**ZONING BOARD OF ADJUSTMENTS  
AGENDA**

Continued public hearing on the request of Heartland Co-Op, represented by David Hoylman from ABP Engineering, for a conditional use permit to allow the expansion of a 'grain storage and distribution' facility in an I-2 District on property legally described as being part of the South 1/2 of Section 4-74-44, lying east of the Missouri River and west of River Road. Location: 2401 South 37th Street

# CITY OF COUNCIL BLUFFS - ZONING BOARD OF ADJUSTMENT CASE #CU-22-004 LOCATION/ZONING MAP

# HEARTLAND GRAIN FACILITY RECEIVING AND STORAGE - BARGE LOADOUT COUNCIL BLUFFS, IOWA

DRAWING NUMBER: 21155-C-101  
REV: C

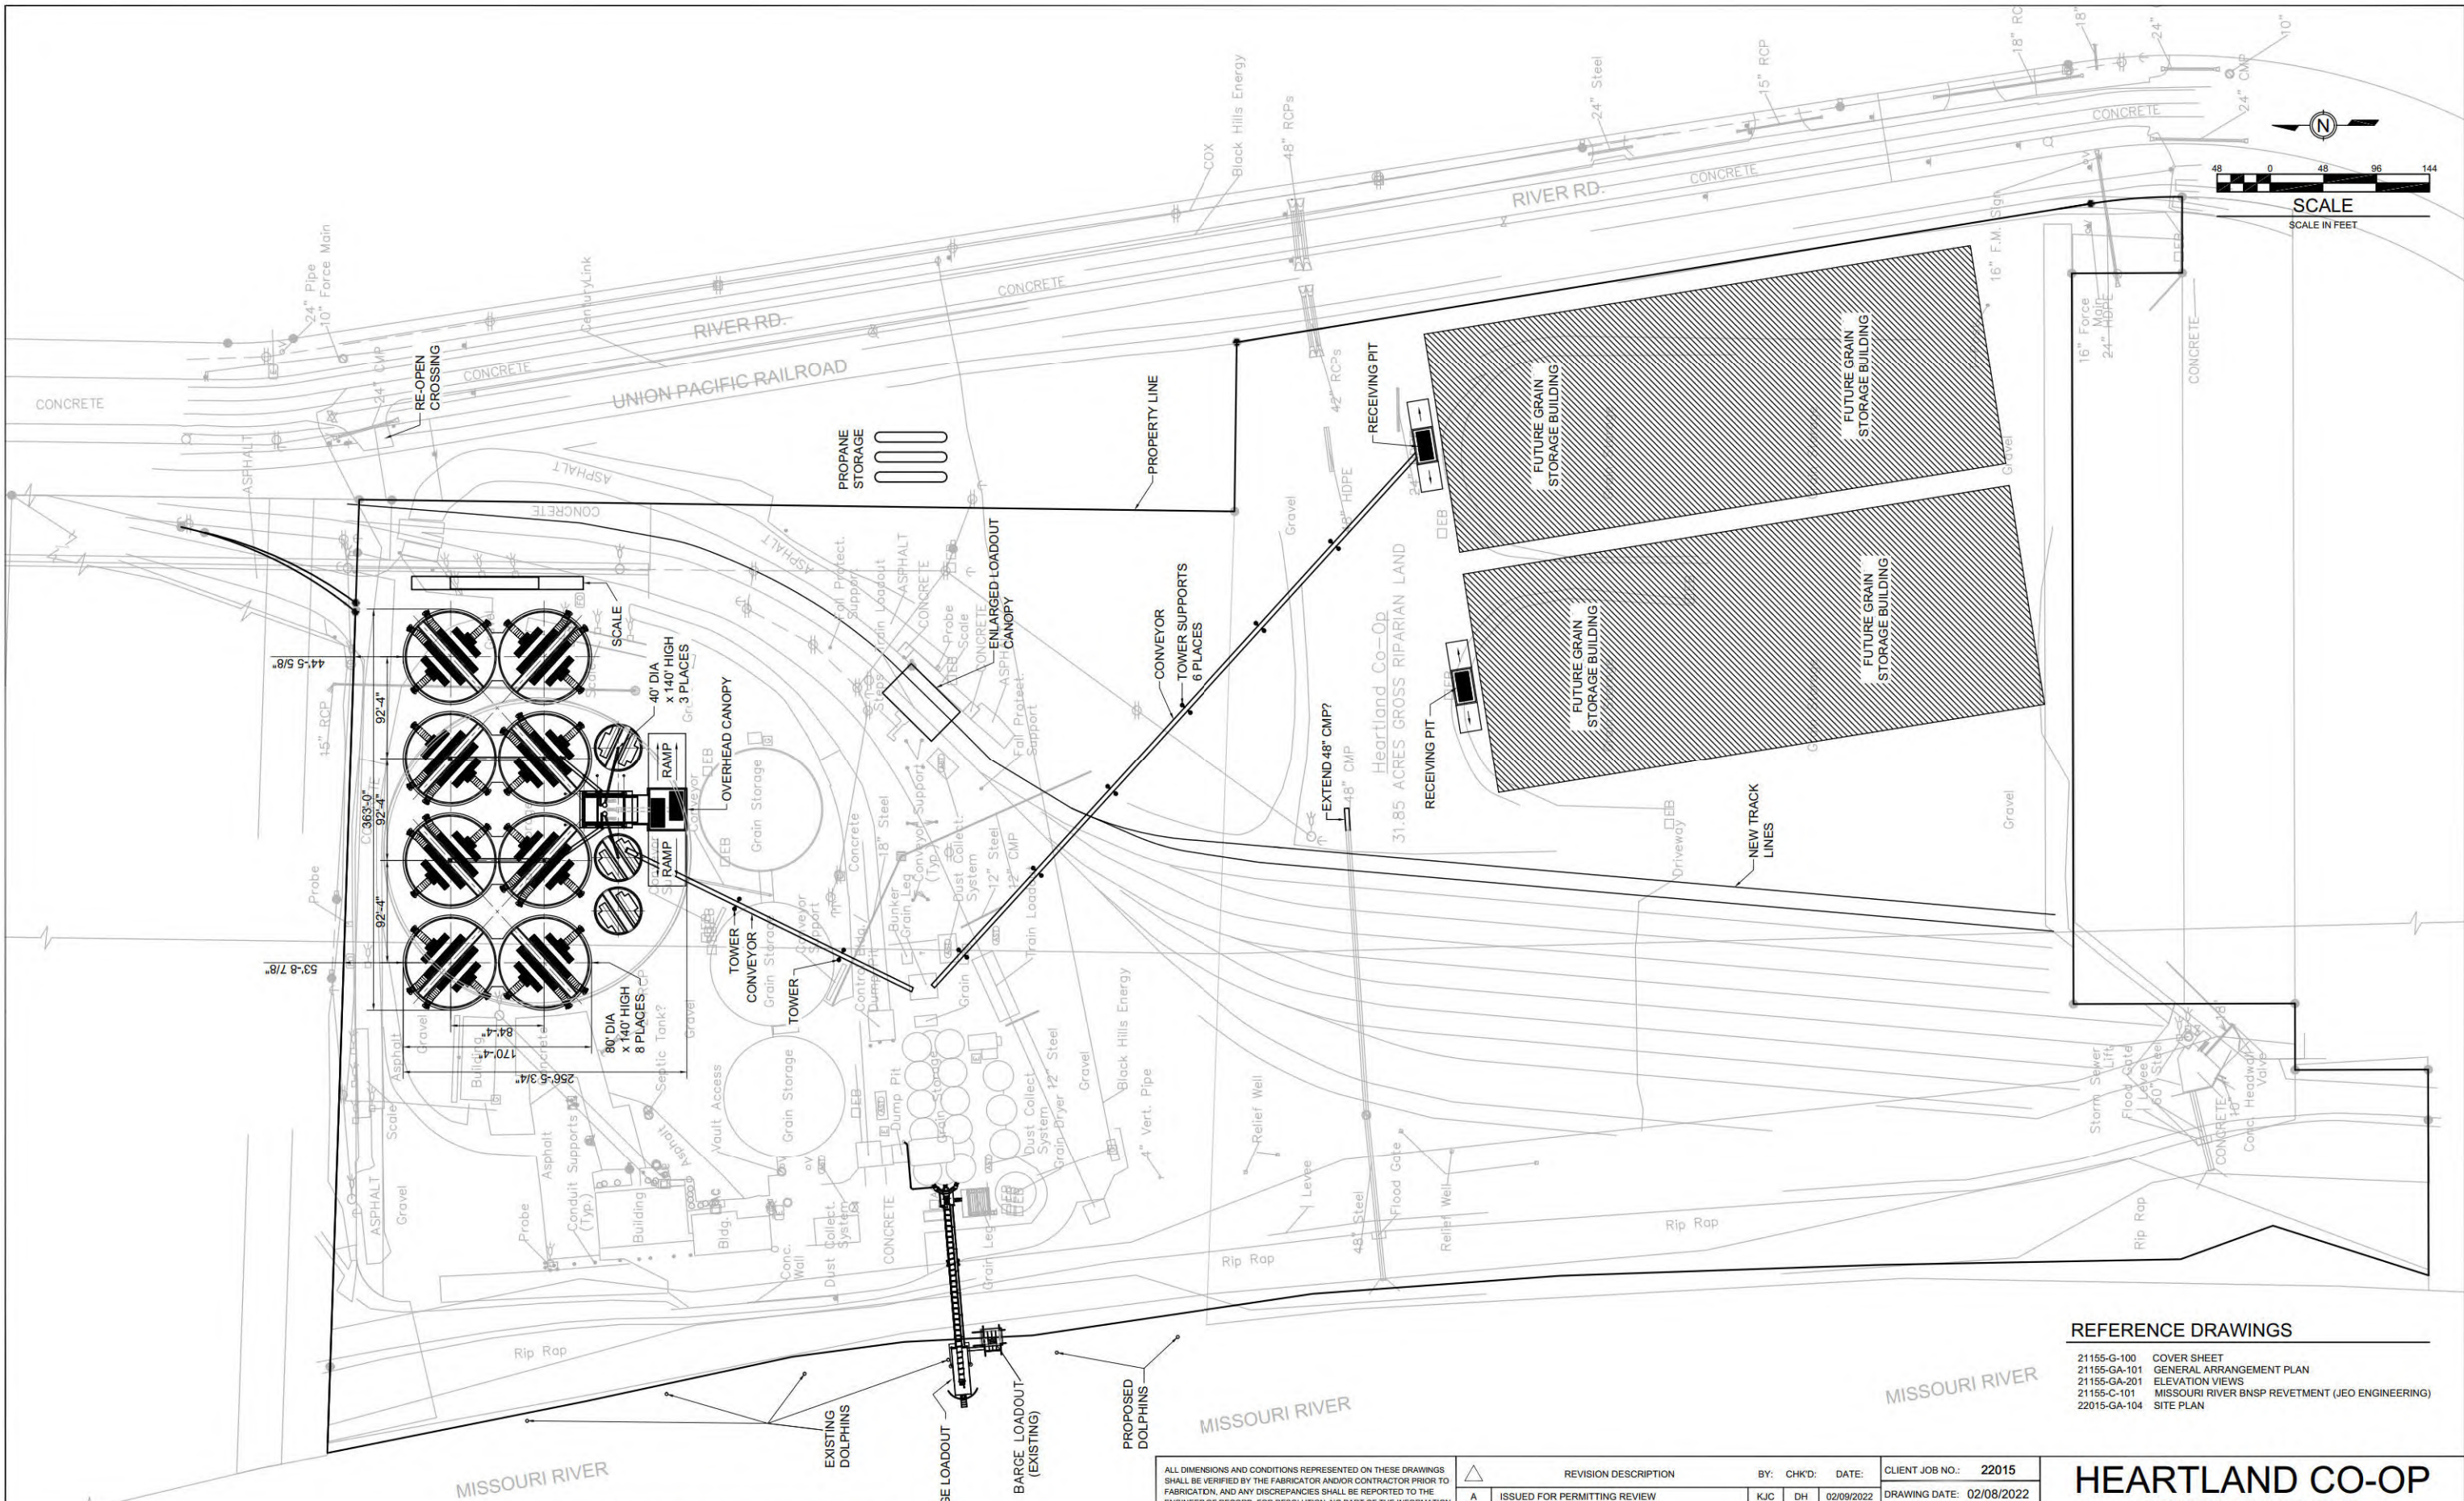
While certain details pertaining to construction methods will be determined by the contractor, ABP has added notes to drawing 21155-C-101 describing replacement of damaged revetment stones and calling for restoration of the revetment to pre-construction as-built conditions.

Revetment stone will not be removed prior to driving piles. Per notes on drawing 21155-C-101, any stones damaged or displaced during construction shall be removed to another location on the levee and replaced.
